Re : Planning and Development Act 2000-2021 and the statutory regulations (as amended). Application by EdgeConneX Ireland Limited for Retention and completion of amendments to the permitted internal road layout, internal fencing and other ancillary internal layout amendments that were permitted under SDCC Planning Ref. SD18A/0298 on this site to the east of the Newcastle Road, Lucan, Dublin

Reg. Ref. SD22A/0009

ADDITIONAL INFORMATION

Permitted road and access arrangements

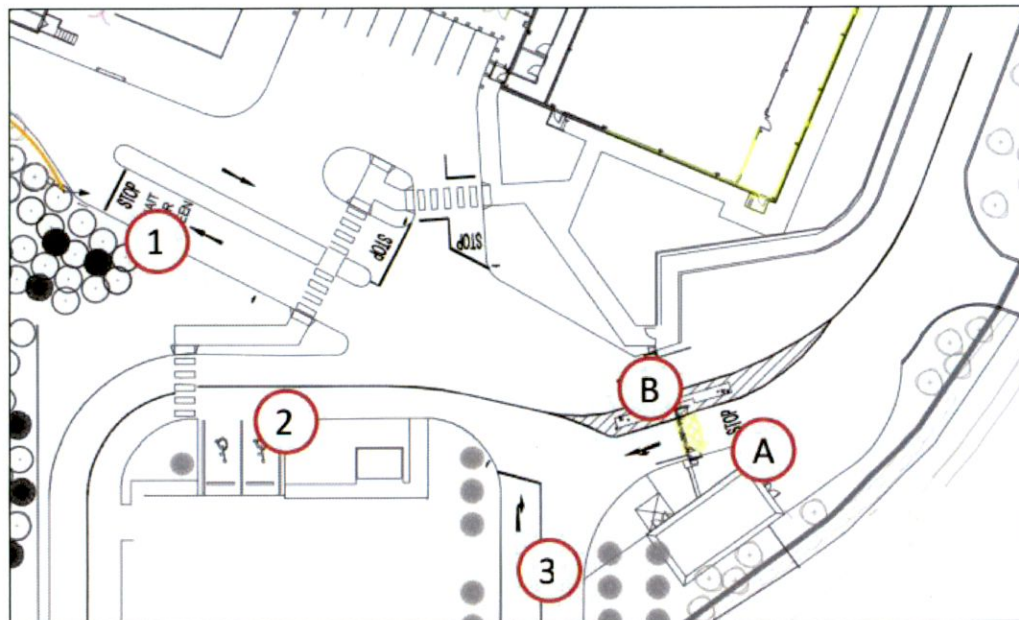
The drawing on the following page is an excerpt from Drawing no. P1.06 from Henry J Lyons that indicates the originally permitted road layout that is subject of this retention of the new road layout. This indicates the permitted vehicular access to the northern part of the data centre campus (Point i) that is to be removed; the location of the fence line (Point ii) to be removed; and the location of the revised road arrangement (Point iii).

- A – all vehicles enter the site via the security gate
- B – all vehicles leave the site via the security gate

1 – Vehicles traveling to the northern half of the campus do so via a metered system. The route to the northern half of the campus is narrow and it is not possible to have two-way traffic. This route involves a signalised system that will meter access to the access route. No vehicles will be allowed to enter the system unless they have a signal to proceed.

2 – Vehicles traveling to the southern half of the campus do so via Route 2 or 3.

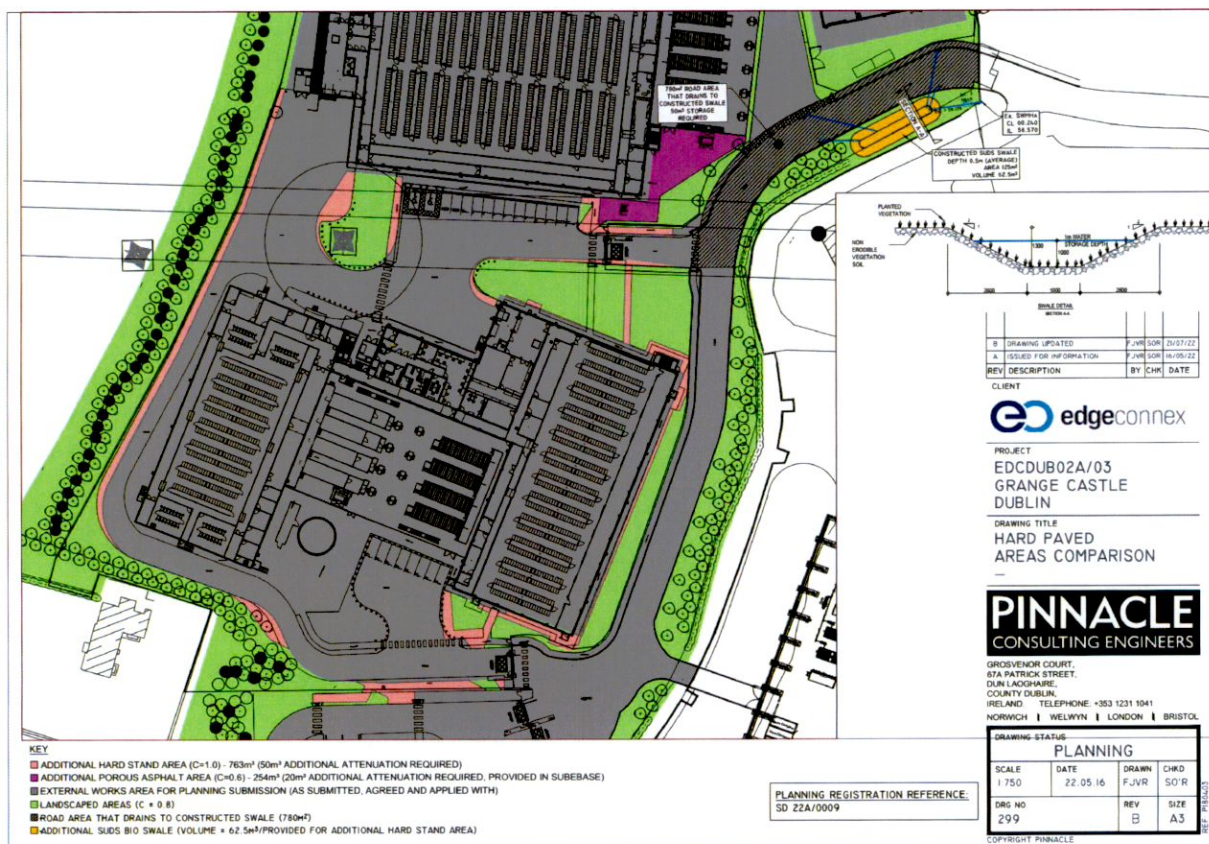
A review of the Clarification of Additional Information request has been comprehensively addressed by Pinnacle Consulting Engineers that addresses the surface water attenuation of the application and overall site in a comprehensive manner. Their response was discussed and agreed with Brian Harkin, Engineer within SDCC prior to the making of this response.

Drawing no. P180403-299 Rev. B submitted by Pinnacle indicates the additional hard paved areas that form part of this retention application, in addition to the associated SUDS elements, ie. Permeable asphalt and a bio-swale (see excerpt below). This indicates an additional area that has been constructed as a permeable asphalt surface above that indicated in the Additional Information submission, that provides an additional 20m³ of storage within the sub-base below the permeable asphalt surface.

The response by Pinnacle Consulting Engineers, indicates that this can therefore reduce the additional 70m³ of storage can be reduced to c. 55m³ from that was outlined in the Clarification of Additional Information. In addition a bio-swale has been constructed as part of the overall campus, and is located to the left and inside the main entrance to the campus.

This swale has the storage capacity of circa 62.5m³, based on the as-constructed width and depth of this feature. This swale is currently catering for a section of access road (asphalt), of circa 780m², which would generate a storage requirement of circa 50m³. The attenuation for this section of road is dealt with via this swale and is not dealt with under the two permitted attenuation ponds to the north of the site. The Pinnacle Report on this issue concludes that they are of the considered opinion that they have adequately demonstrated that the applicant has provided additional attenuation storage for this application in the order of 82.5m³, i.e. 20m³ (permeable asphalt) & 62.5m³ (bio-swale) within the overall campus, which is in excess

of 27.5m³ over the agreed reduced storage volume of 55m³. There is therefore adequate surface water attenuation to address the SUDS requirements of the revised road arrangement as proposed under this application.
